Geotechnical Investigation

Arcadia – Stage 6
Campeau Drive - Ottawa

Report PG5648-1 Revision 8 dated August 1, 2023

re: Geotechnical Response to City Comments
Proposed Residential Development
Arcadia – Stage 6
Campeau Drive - Ottawa
to: Minto Communities – Mr. Curtiss Scarlet - CScarlett@minto.com
date: February 1, 2022
file: PG5648-MEMO.01 Revision 1

Title: **LIMIT OF HAZARD LANDS - A**

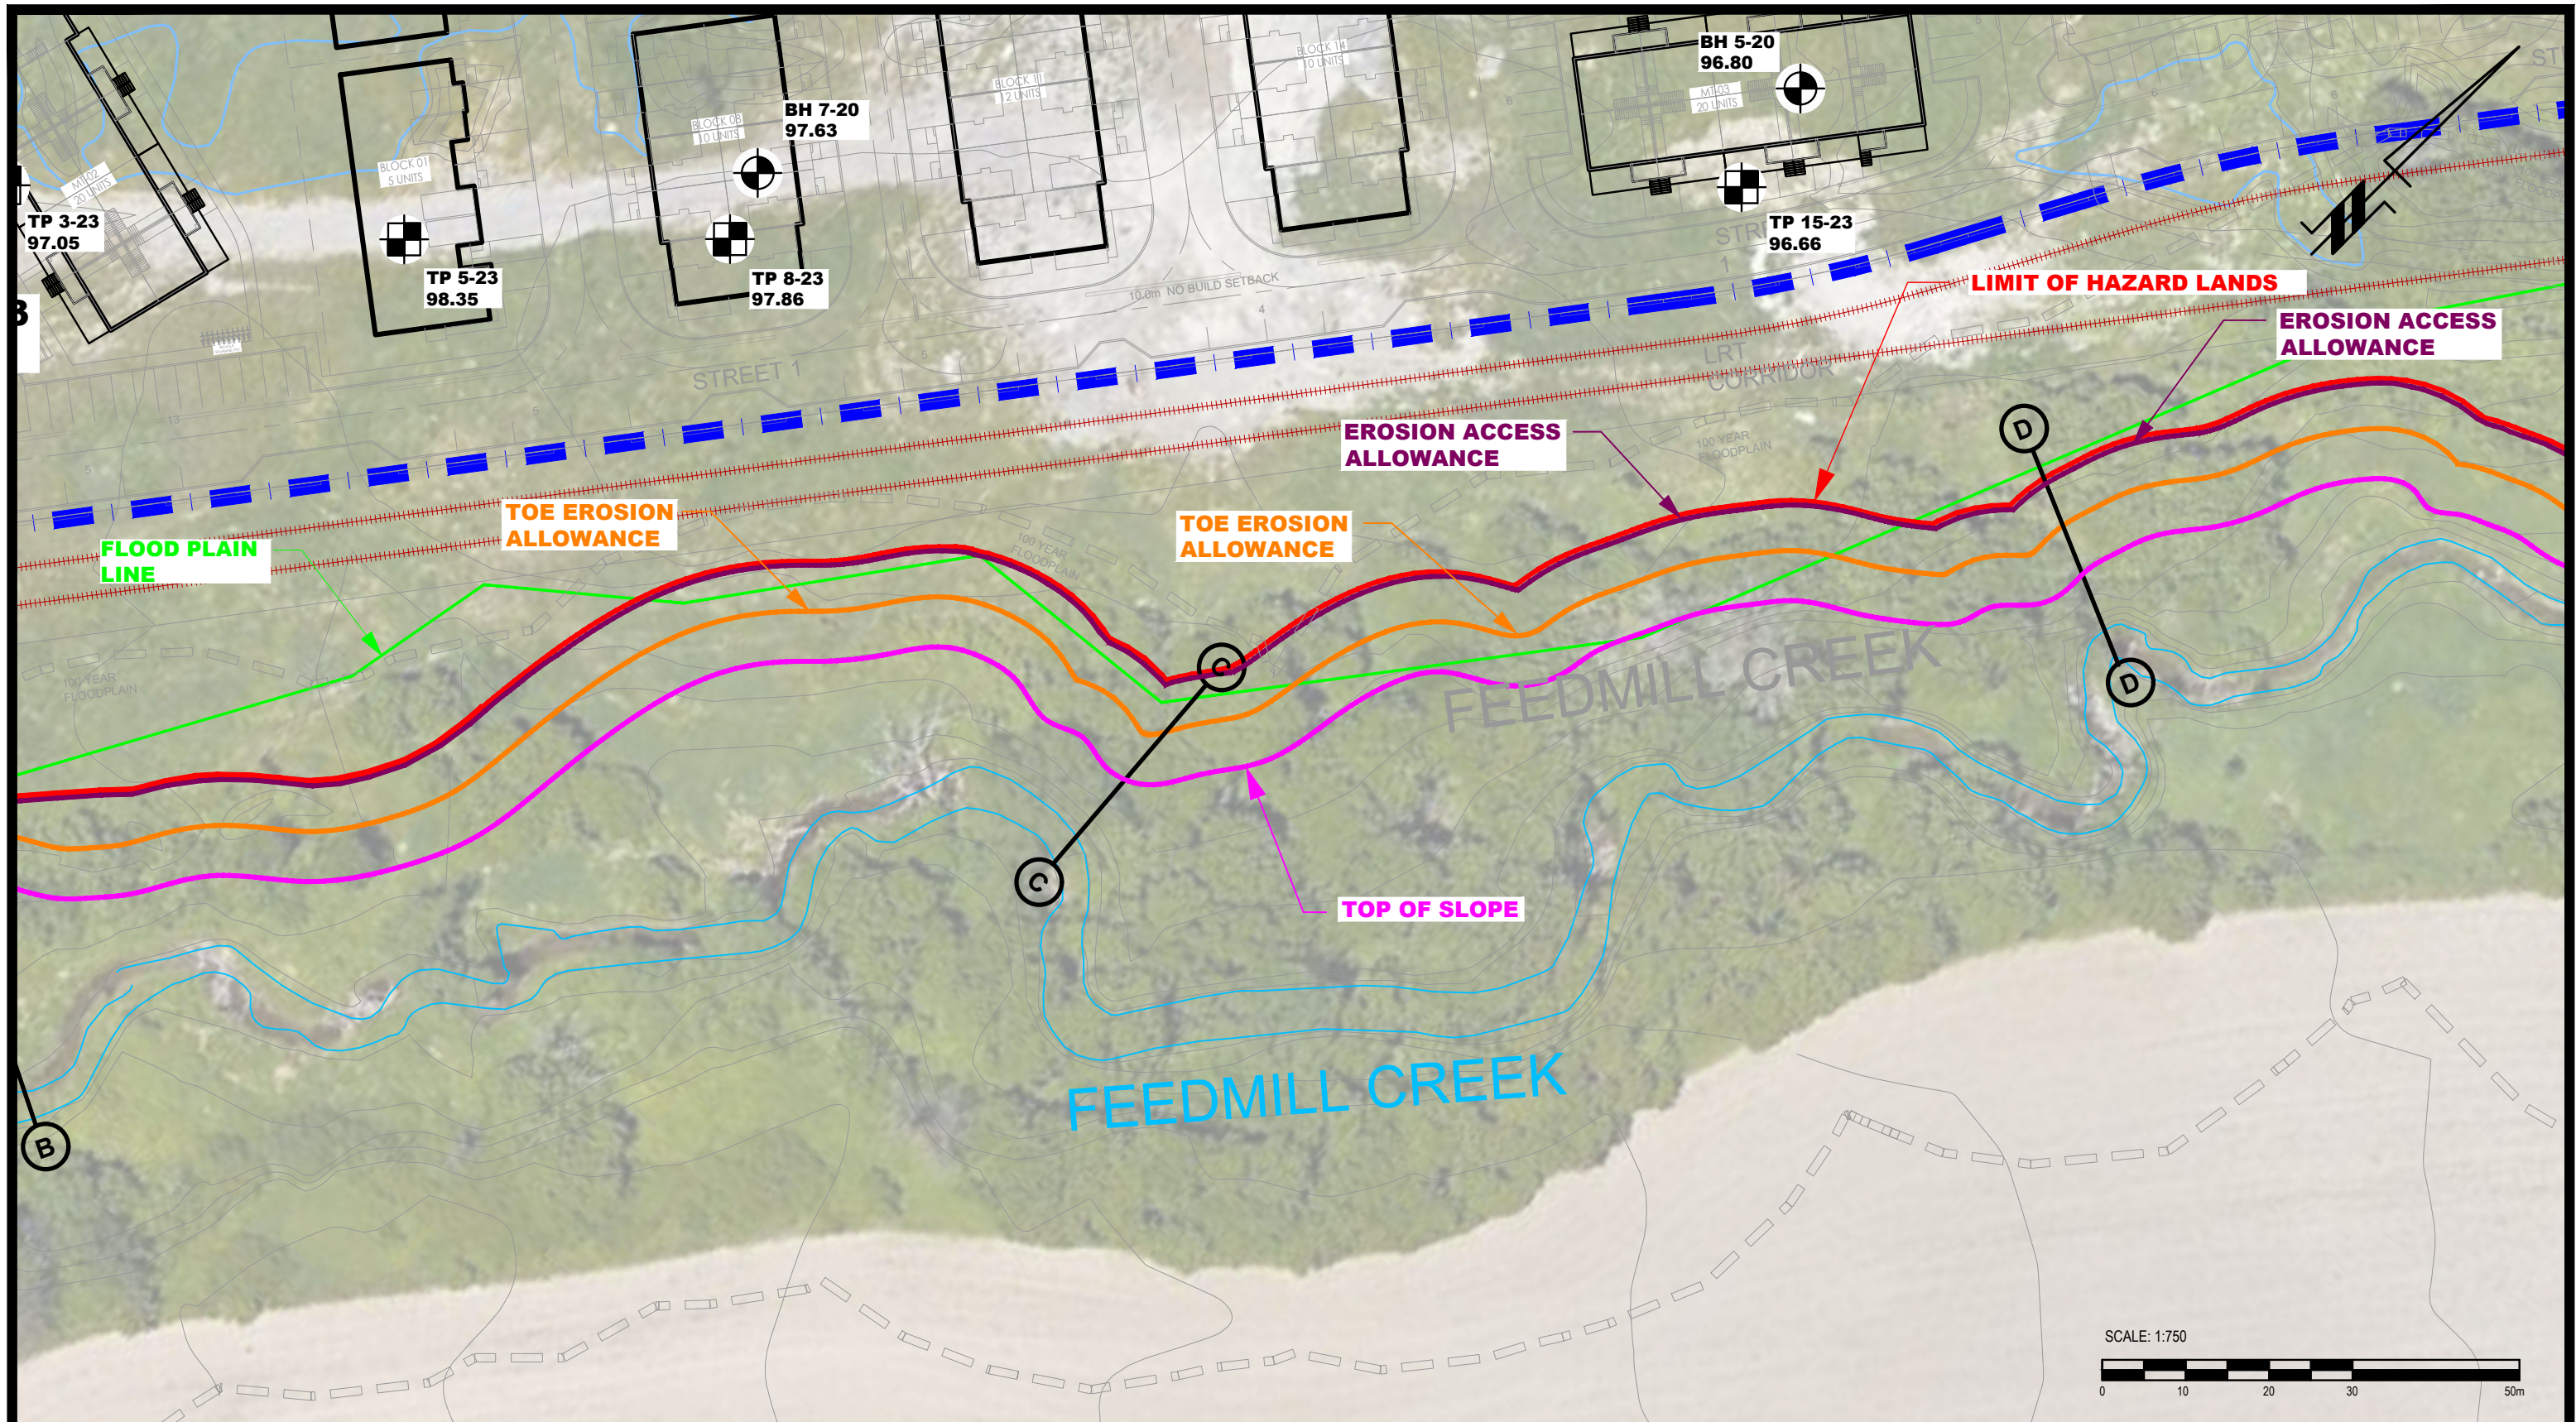
Please provide and delineate the proposed 6 m toe erosion allowance at the west portion, section A-A to section B-B (Drawing PG5648-3A).

Response: Based on the topographic survey and on our field survey, the width of the valley floor along the slope between sections A-A and B-B is greater than 15 m. Therefore, based on the *MNR's Technical Guide – River and Stream Systems: Erosion Hazard Limit*, no toe erosion allowance is required for this section of the slope.

MINTO COMMUNITIES
GEOTECHNICAL INVESTIGATION
PROPOSED RESIDENTIAL DEVELOPMENT - ARCADIA - STAGE 6
 OTTAWA, ONTARIO
 Title: **LIMIT OF HAZARD LANDS - B**

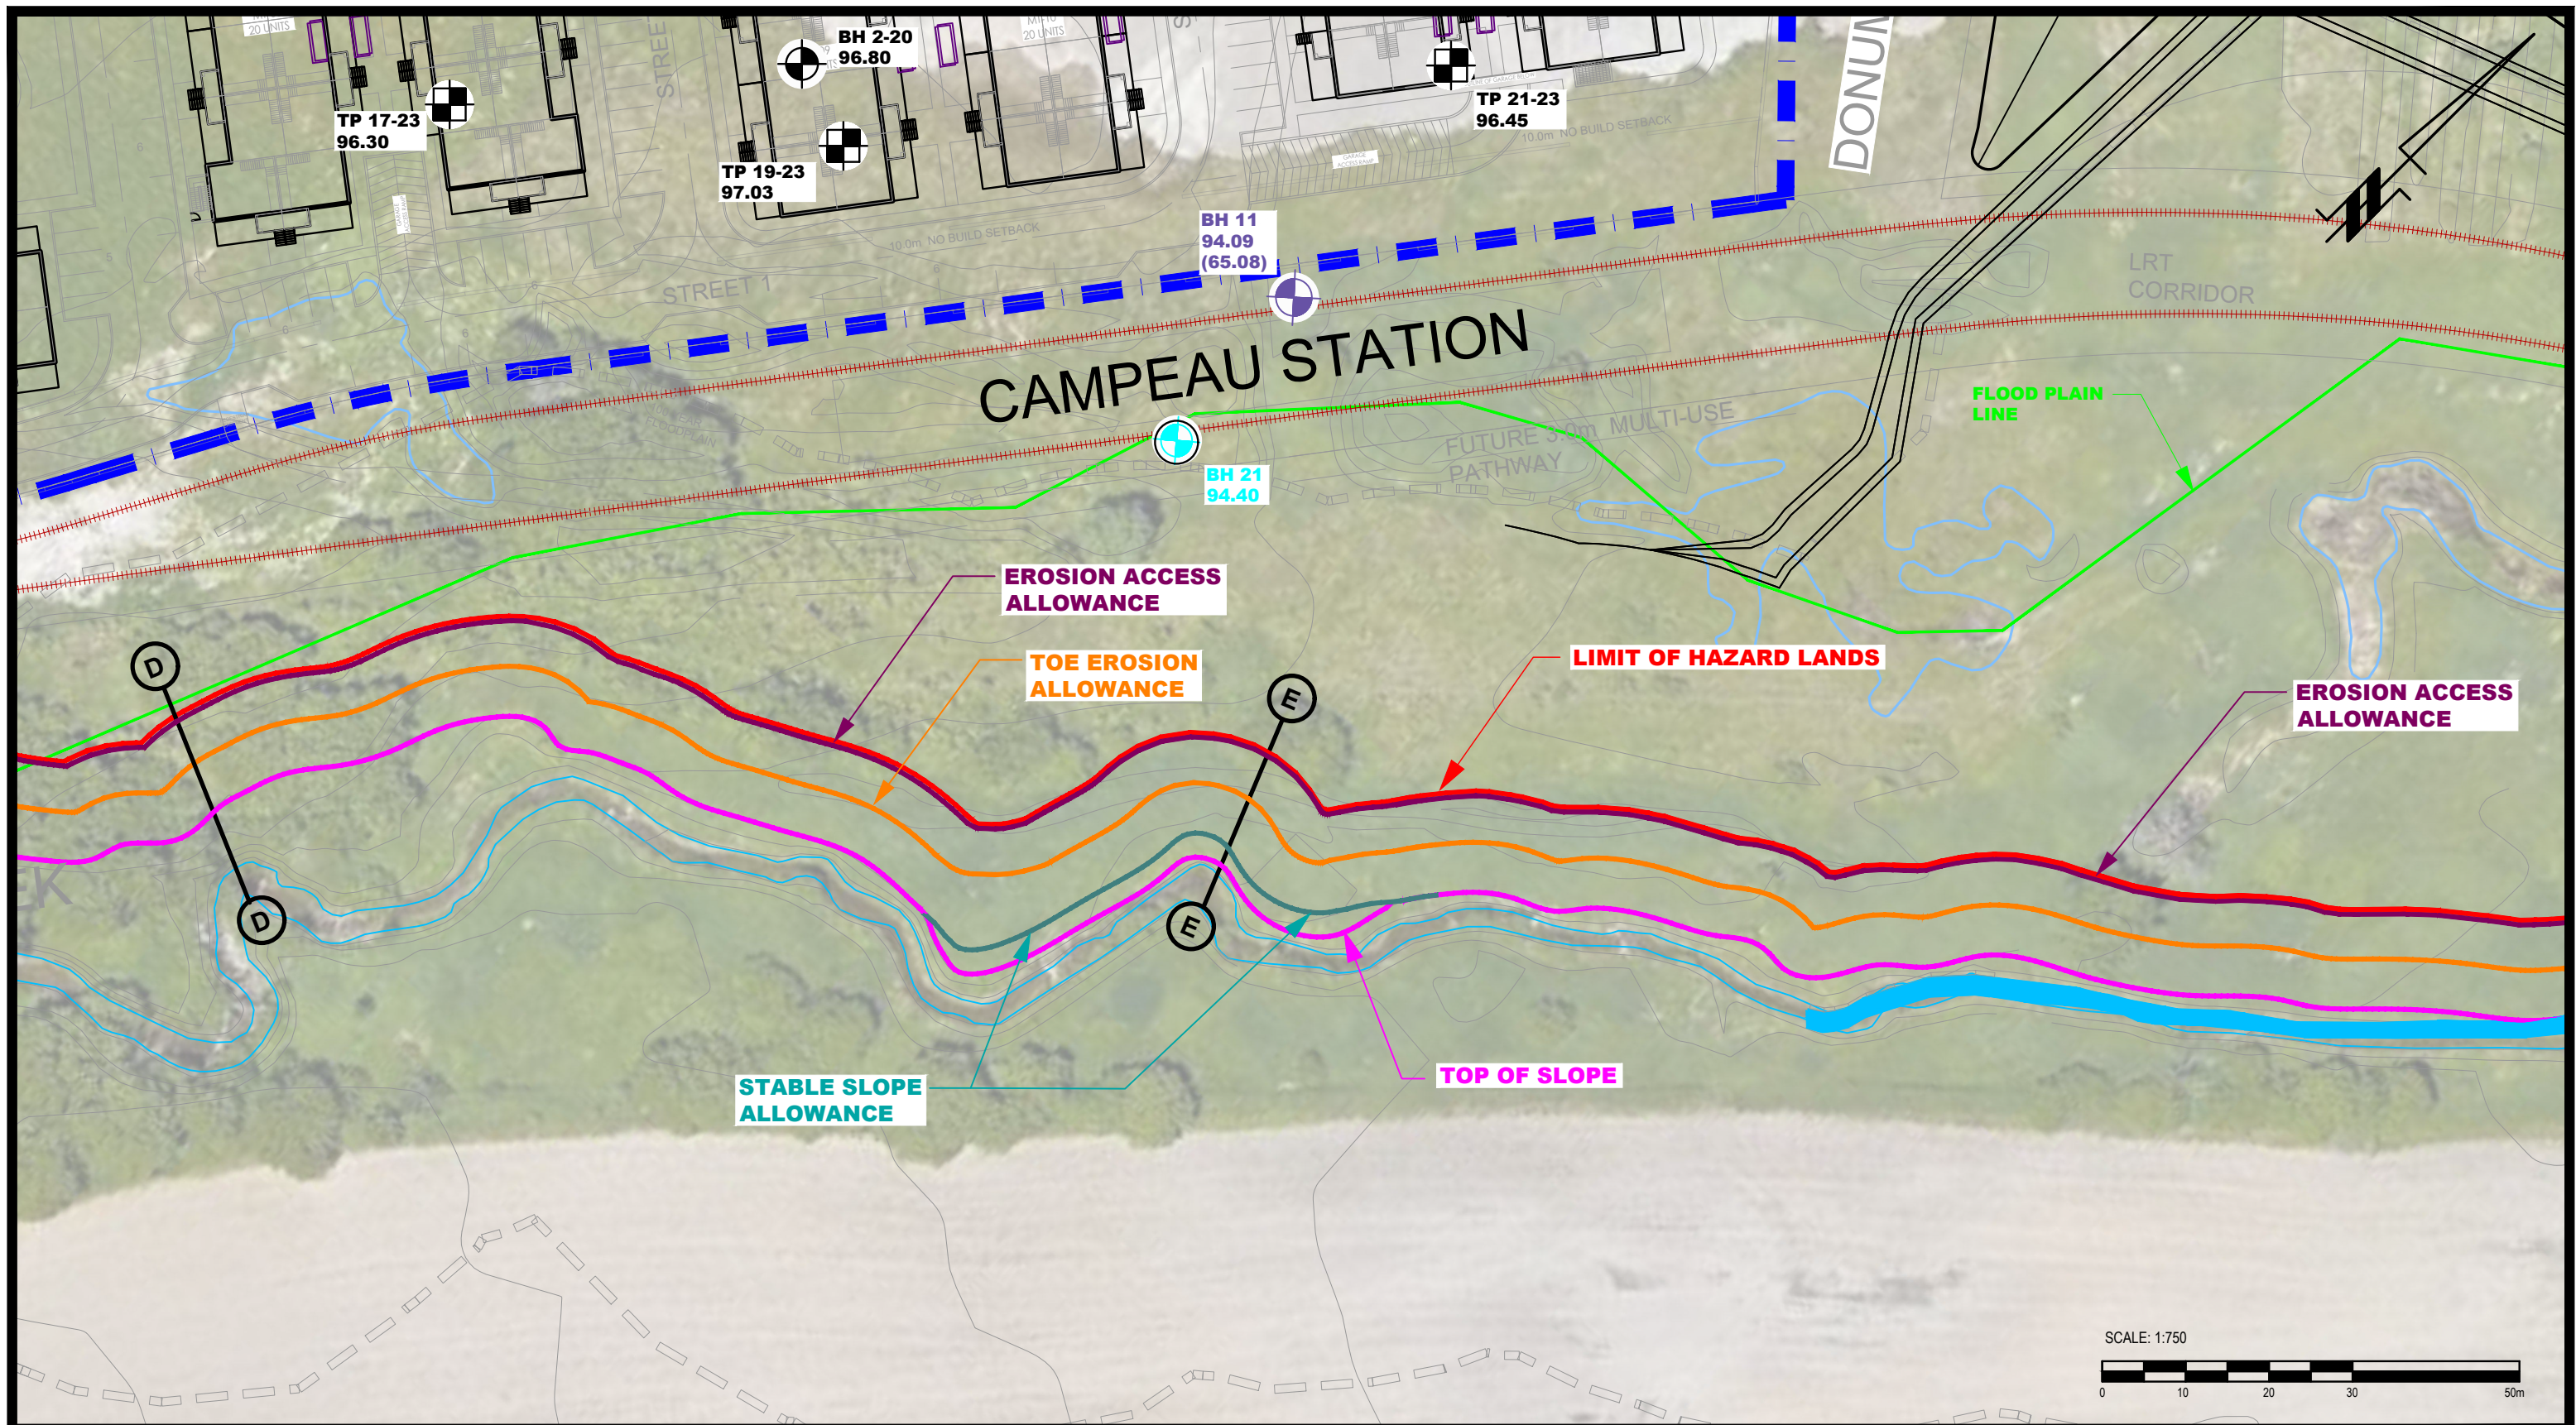
Please address the variable 6 m erosion access allowance vary along section A-A to section C-C (Drawing PG5648-3B).

Response: The erosion access allowance along the whole alignment shall be 6m minimum. Paterson revised the limit of hazard lands drawings to show the required 6 m erosion access allowance. Reference should be made to our revised drawings PG5648-3, PG5648-3A, PG5648-3B, PG5648-3C, and PG5648-3D enclosed in Appendix 2 of our geotechnical report PG5648-1 Revision 3 dated February 1, 2022.

MINTO COMMUNITIES
GEOTECHNICAL INVESTIGATION
PROPOSED RESIDENTIAL DEVELOPMENT - ARCADIA - STAGE 6
 OTTAWA, ONTARIO
 Title: **LIMIT OF HAZARD LANDS - C**

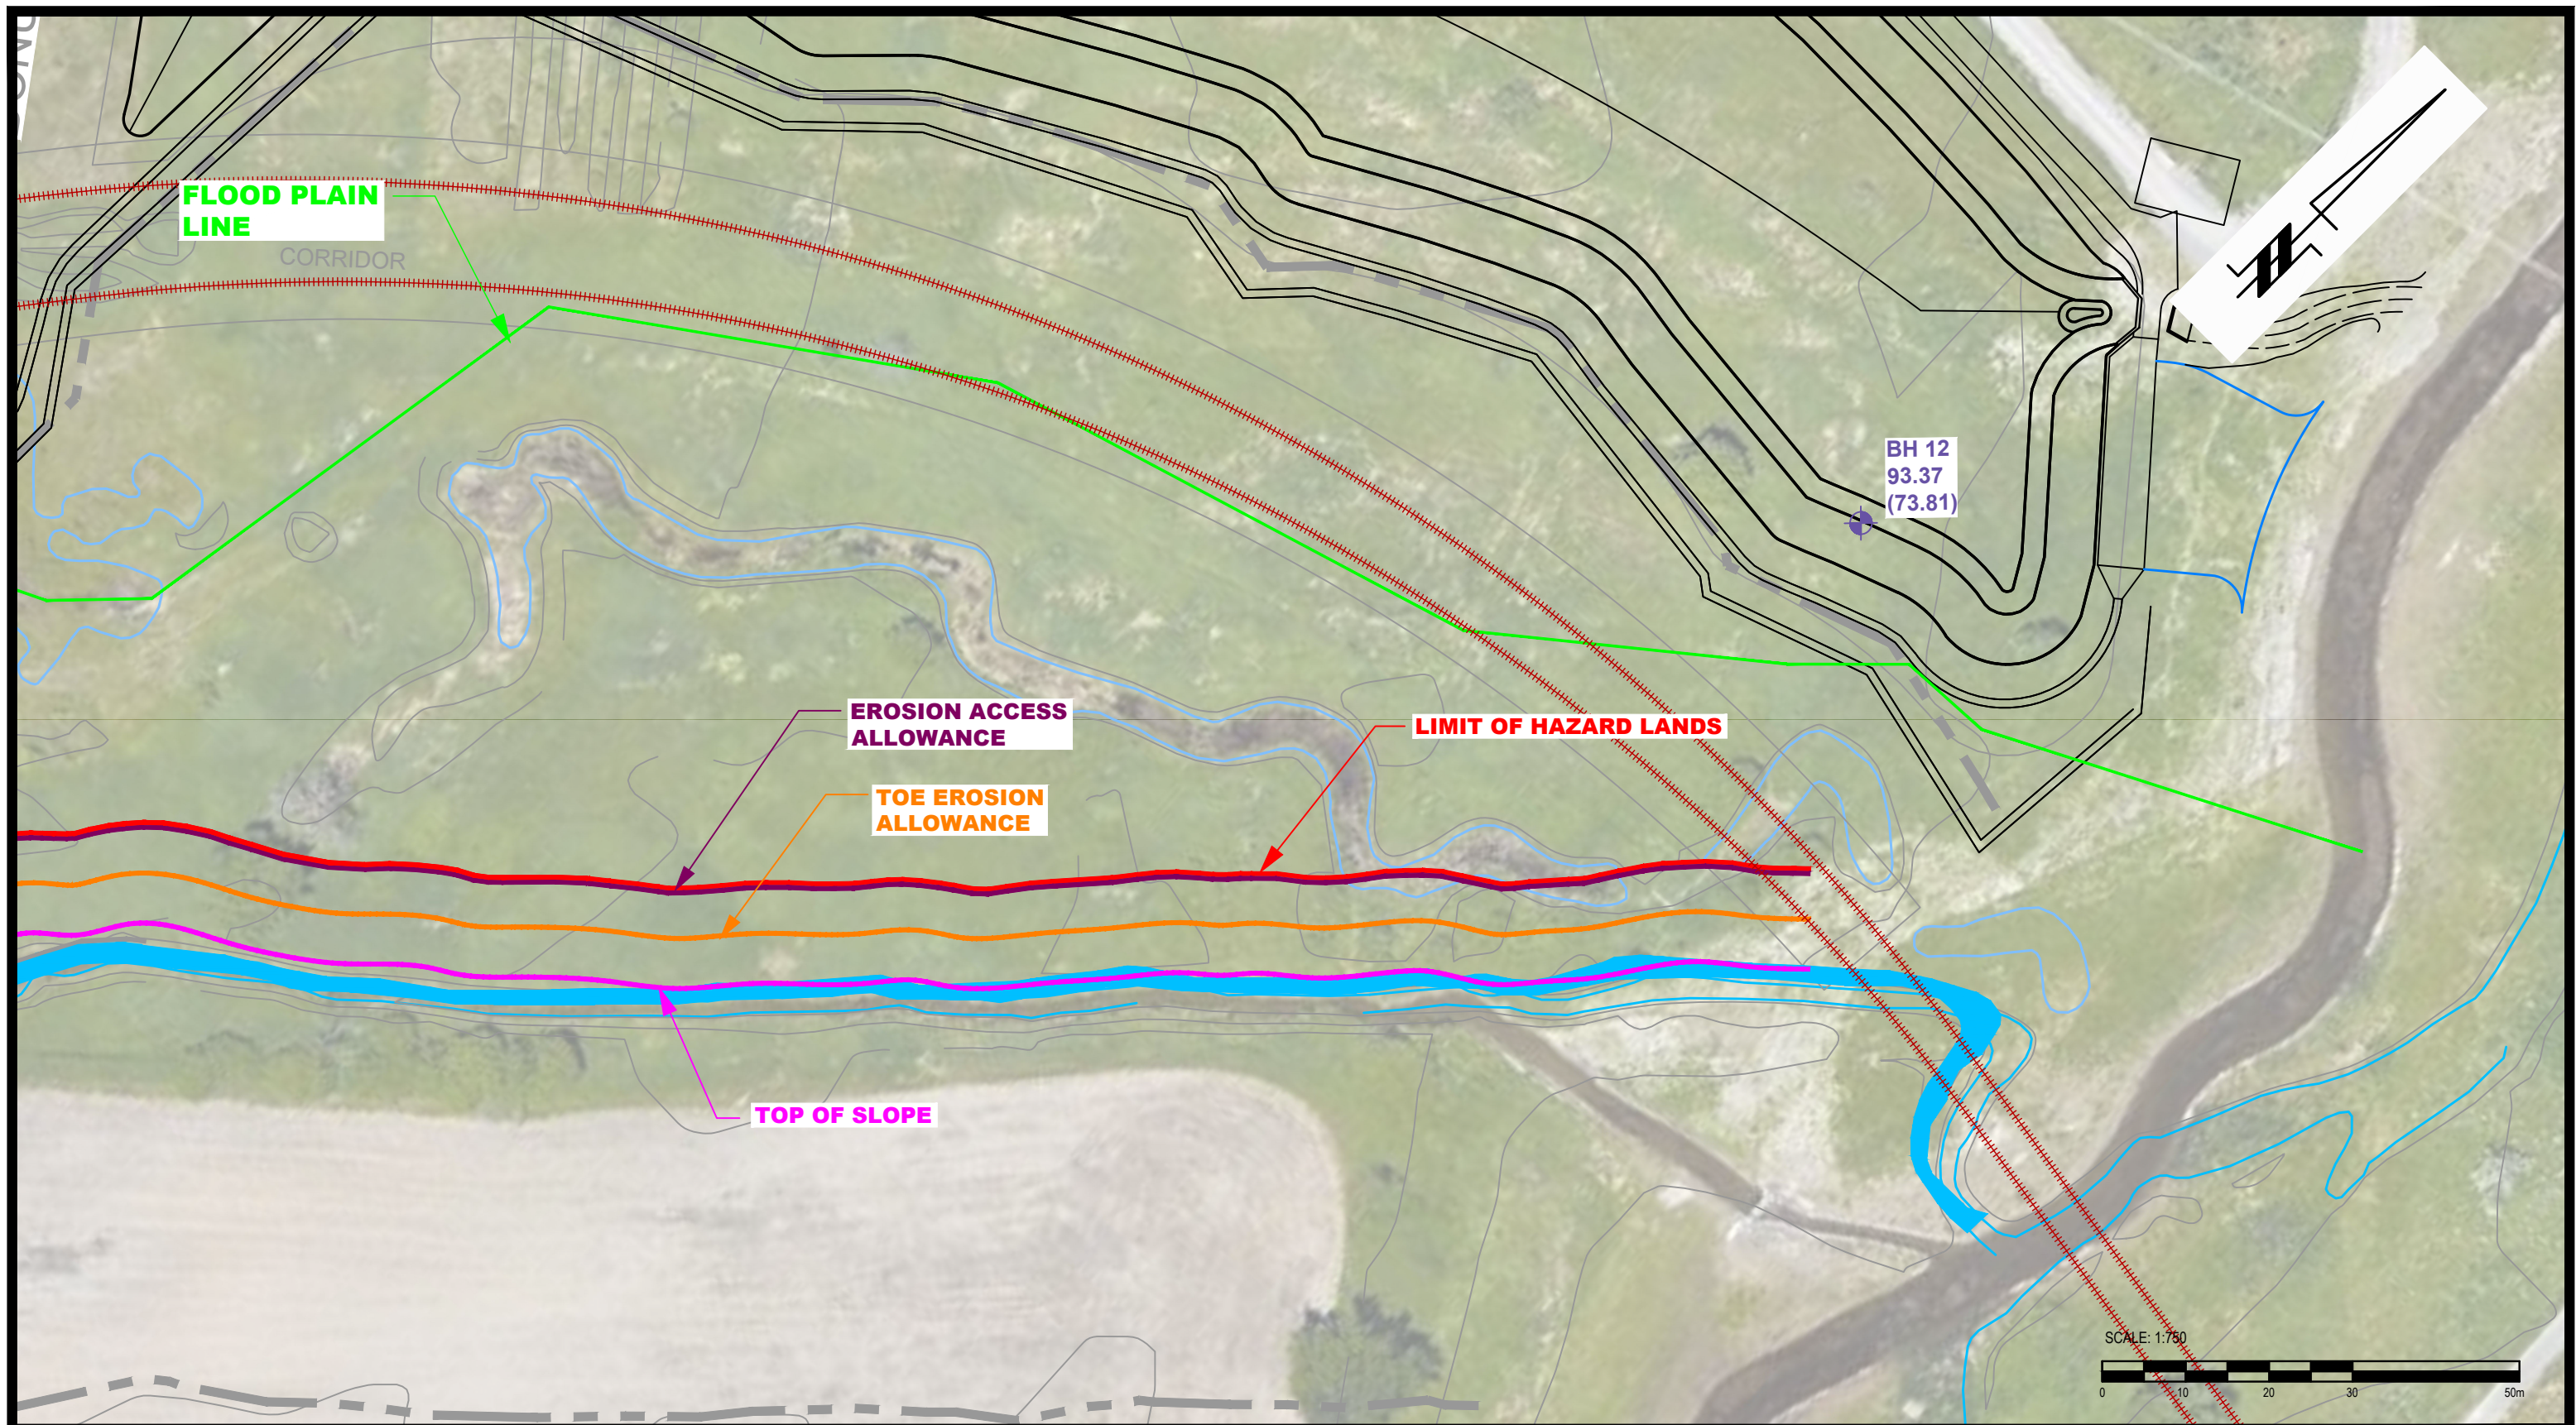
Why did the proposed 2.9 m stable slope allowance vary at section E-E (Drawing PG5648-3C)?

Response: The stable slope allowance at section E-E is constant and equal to 2.9 m. Please refer to our revised drawing PG5648-3D enclosed in Appendix 2 of our geotechnical report PG5648-1 Revision 3 dated February 1, 2022, for the correct stable slope allowance limit.
